Country Club Creek Trail-  
Elmont Dr. to E. Oltorf St.

SP-2022-0197D

# Variance Requests

E Riverside Bridge – looking north – location of cut for variance request

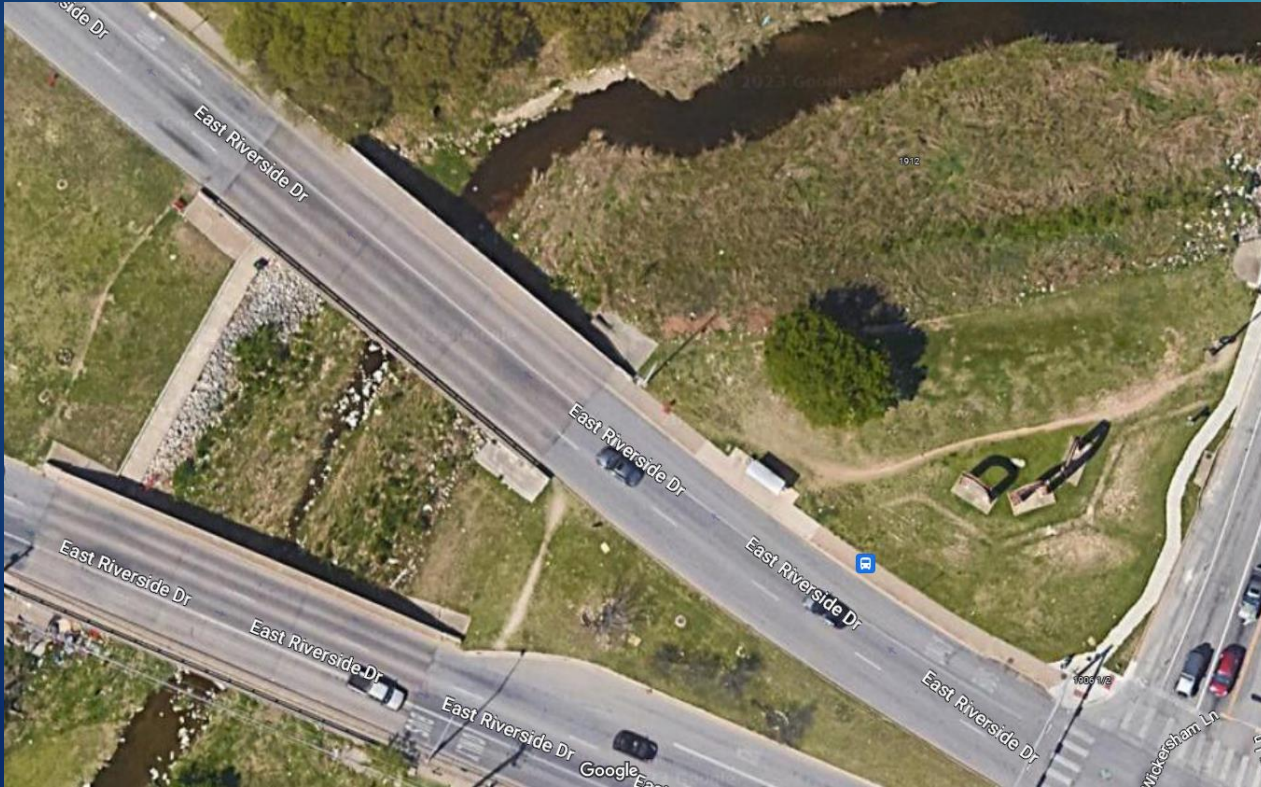
- ▶ The cut for the trail is triggered where the trail runs under the 2 span bridges for E. Riverside Dr. and then rises back up to meet Wickersham Lane.
- ▶ The cut is located on slopes over 15% and within 100 feet of a classified waterway.

# Grading Exhibit at E. Riverside Dr.

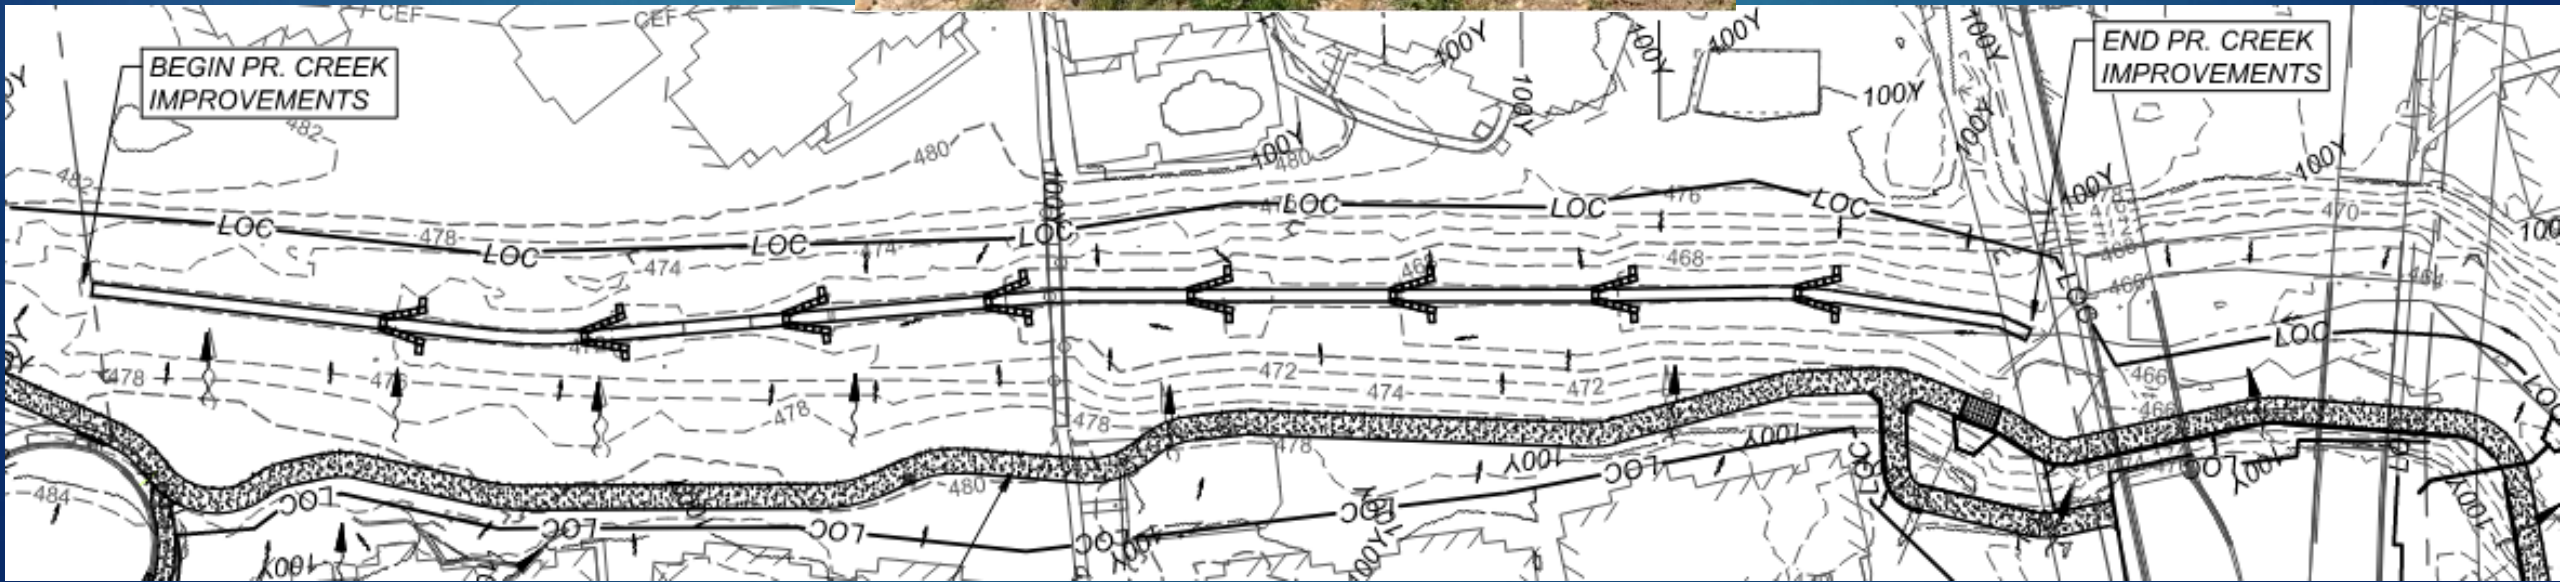
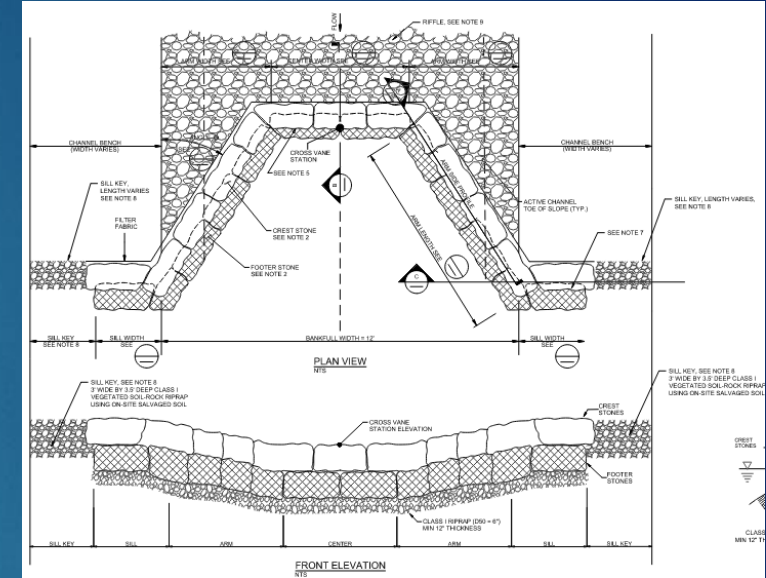
- ▶ To allow cut over 4 feet on slopes over 15% within the Desired Development Zone. (LDC 25-8-341)
- ▶ Max cut proposed is approximately 10 feet in depth.

Staff recommends the variance, having determined that the required findings of fact have been met.

Staff also recommends and supports the following condition:

- **Provide structural containment of cut with retaining walls**

# Grading Within Creek

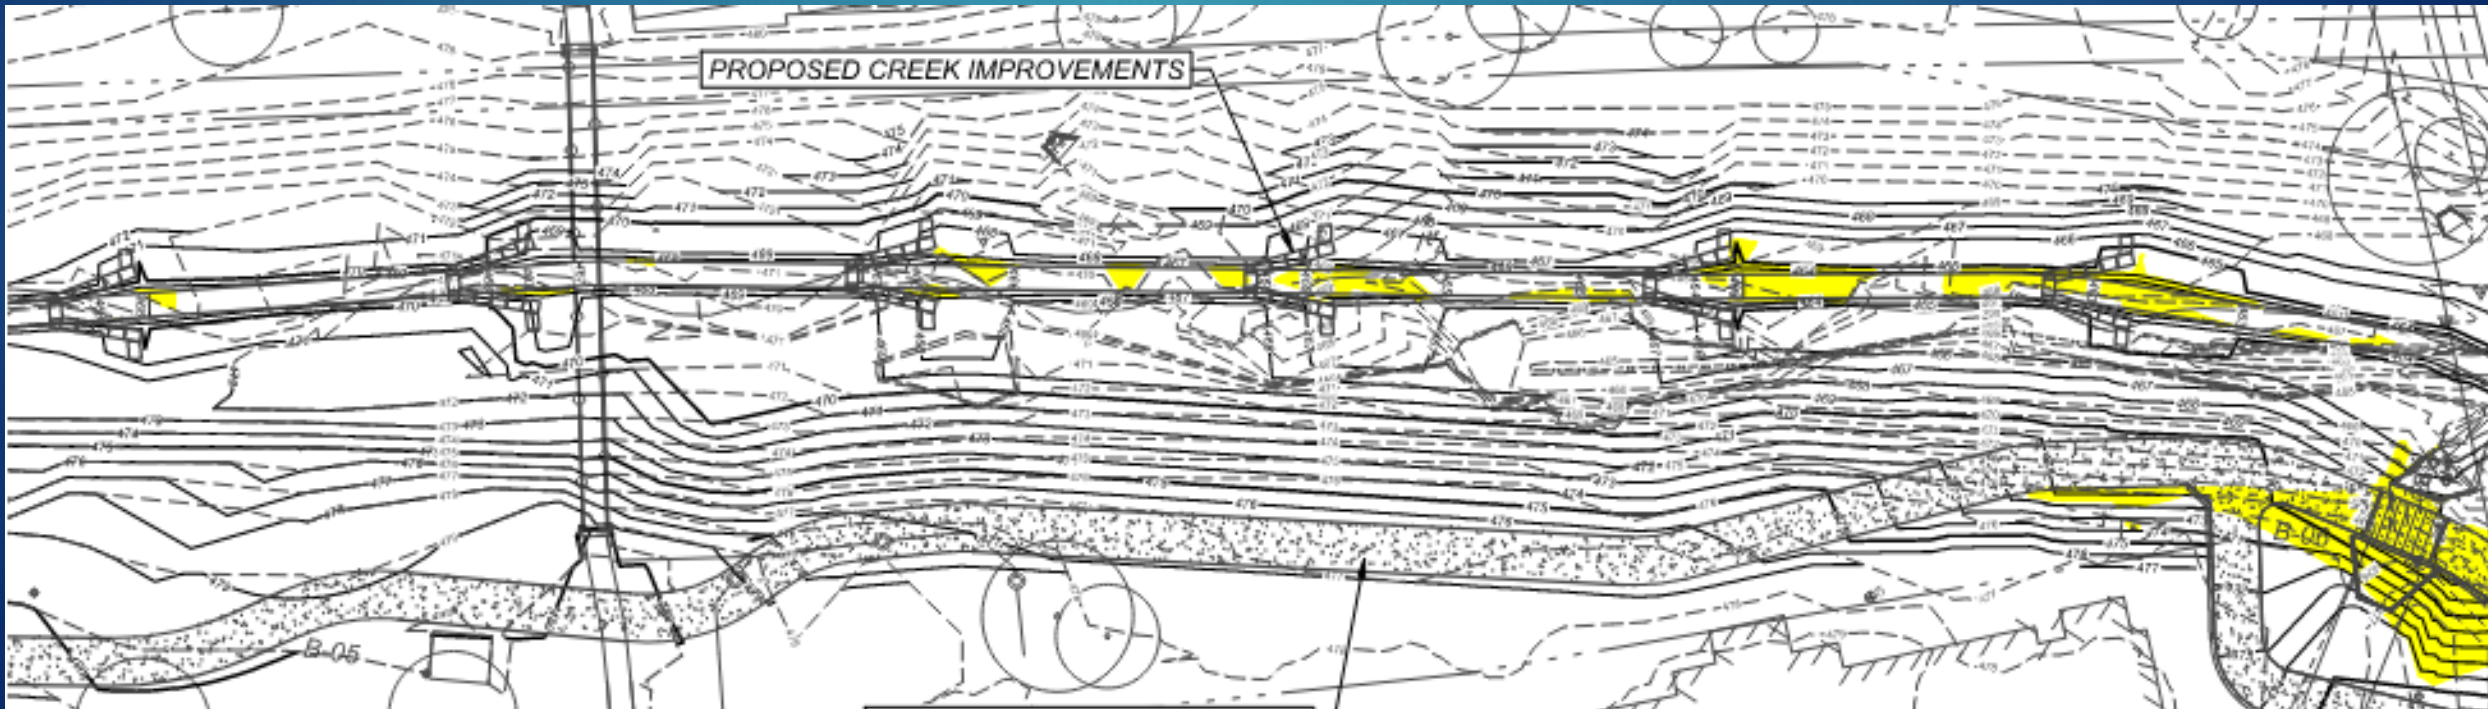
- ▶ The cut for the trail is triggered where the trail runs under the 2 span bridges for E. Riverside Dr. and then rises back up to meet Wickersham Lane.
- ▶ The cut is located on slopes over 15% and within 100 feet of a classified waterway.
